CASE SUMMARY SHEET

CASE NUMBER: V26-03-05**DATE RECEIVED: January 22, 2026****DATE OF MEETING: March 10, 2026 and March 24, 2026****Address: 2801 Lakeshore****Subdivision: West Beach Parkway, Square 1 Lot 1-A****Zoning District: R-1 - Single Family Residential District****Property Owner: William and Caroline Alquist**

REQUEST: V26-03-05 – William and Caroline Alquist request a variance to CLURO Section 5.2.3.2. Drainage Overlay District and Fill Sub-Area A, Section 9.2.5.2. Vegetation Protection Zones, and Section 8.1.5. Supplemental Regulation of Accessory Buildings and Structures, West Beach Parkway, Square 1 Lot 1-A, R-1 - Single Family Residential District, 2801 Lakeshore

CASE SUMMARY: Construct a raised pool within the street side setback and a live oak vegetation protection zone

1 SITE PLAN WITH EXISTING TREE DRIPLINES
 A3.8 1/16" = 1'-0"

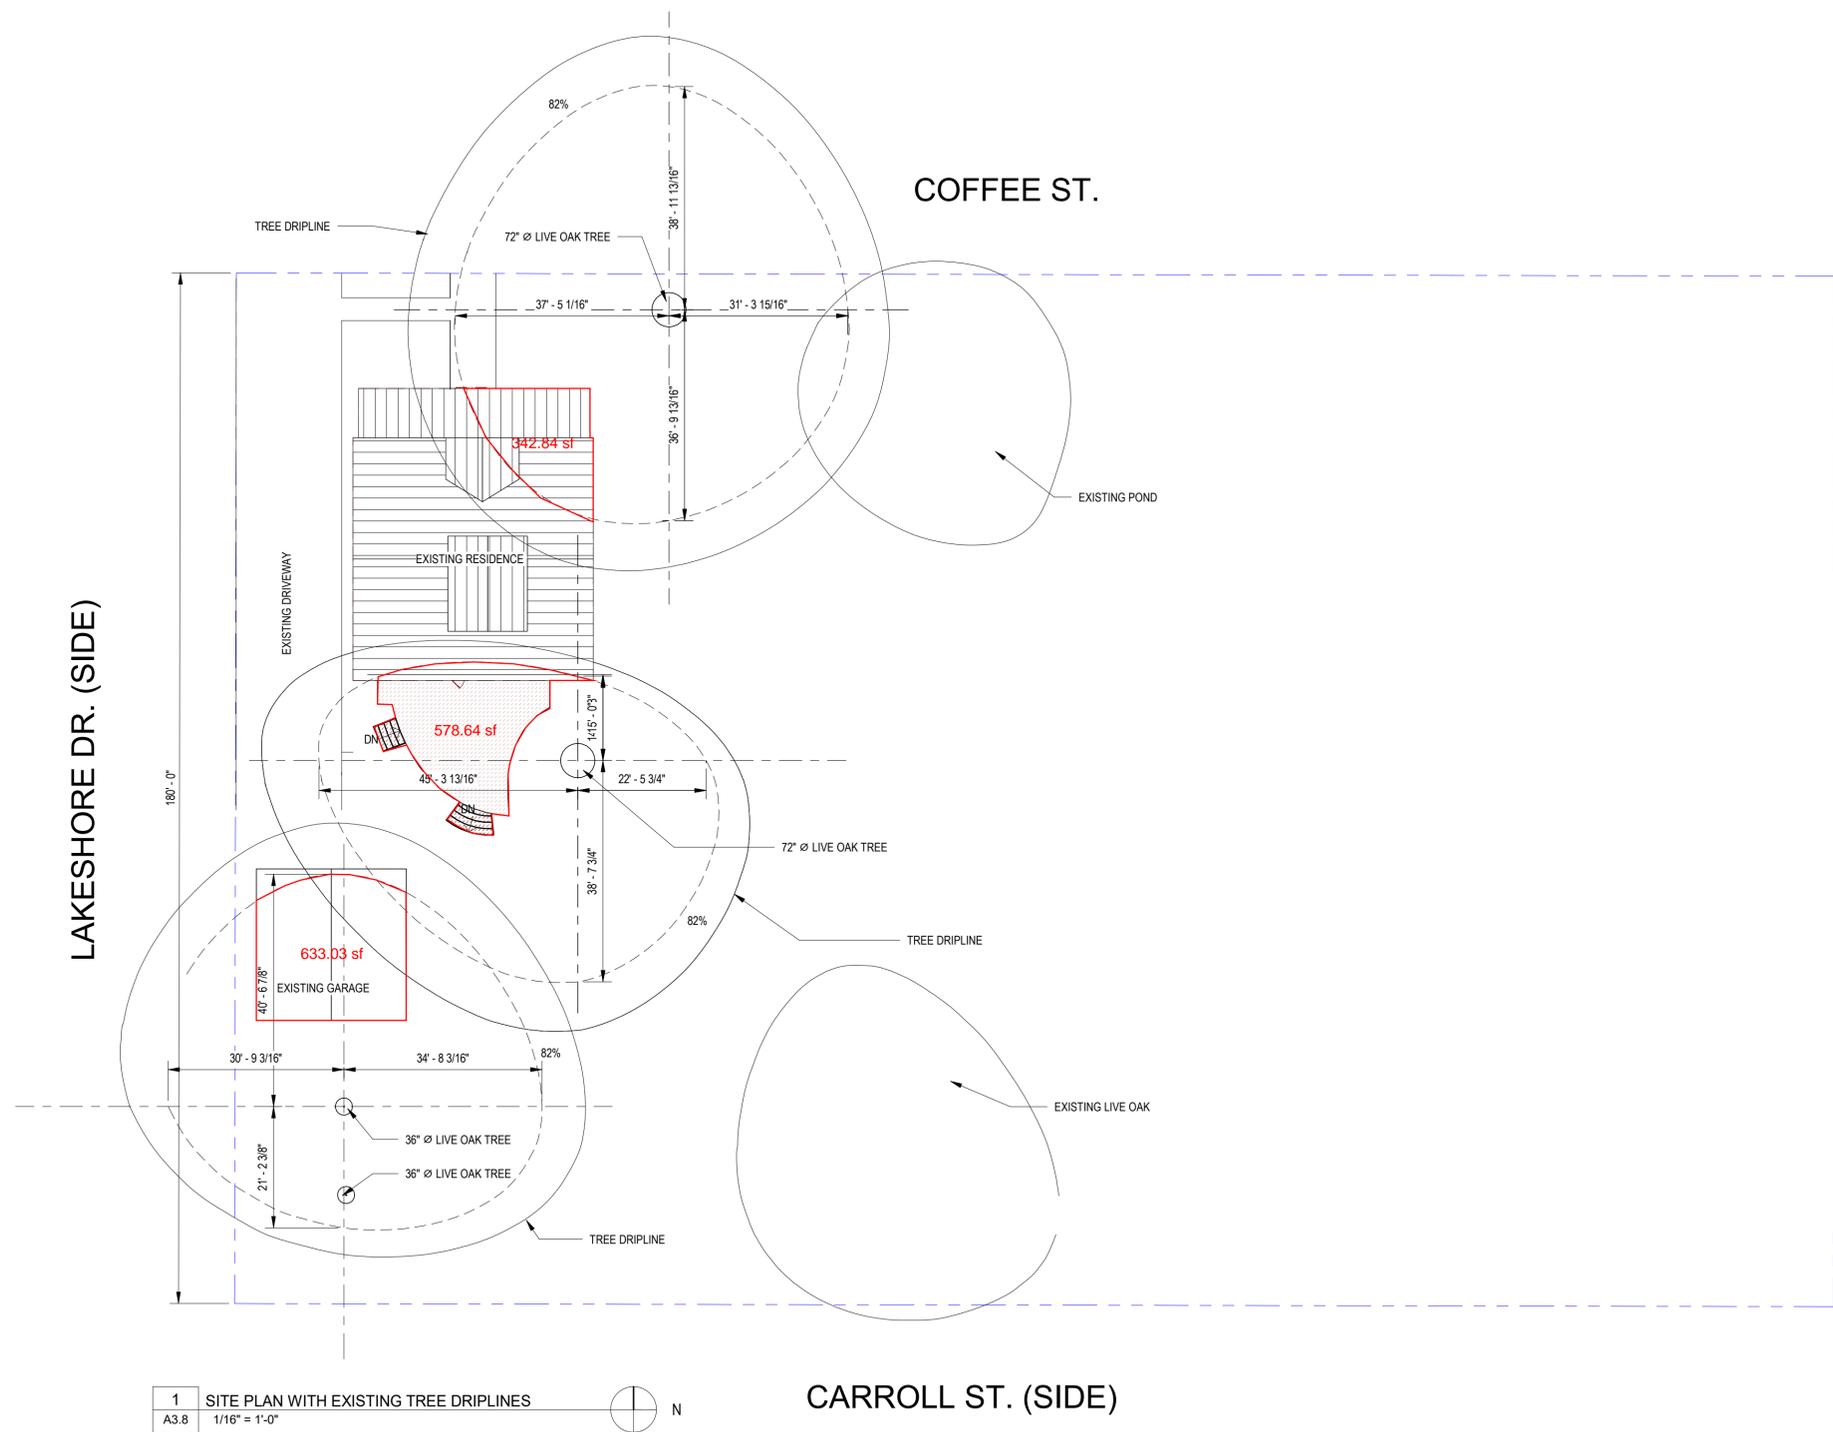
I do think that vertical mulching is a great idea and will benefit the tree. I also could have approved a fence permit if it was submitted prior to the installation and showed that the soil disturbance was no greater than 3 inches deep within the dripline of the tree. However, I disagree with your arborist's assessment that the tree roots were not harmed. I measured about 12 inches of disturbance (depth) near the base of the tree and at least 5 inches in several other places. The CULRO -specifically article 9.1.2 does not give me the power to approve something with this much disturbance. Therefore, a variance is still required for something of this depth within the dripline of the tree.
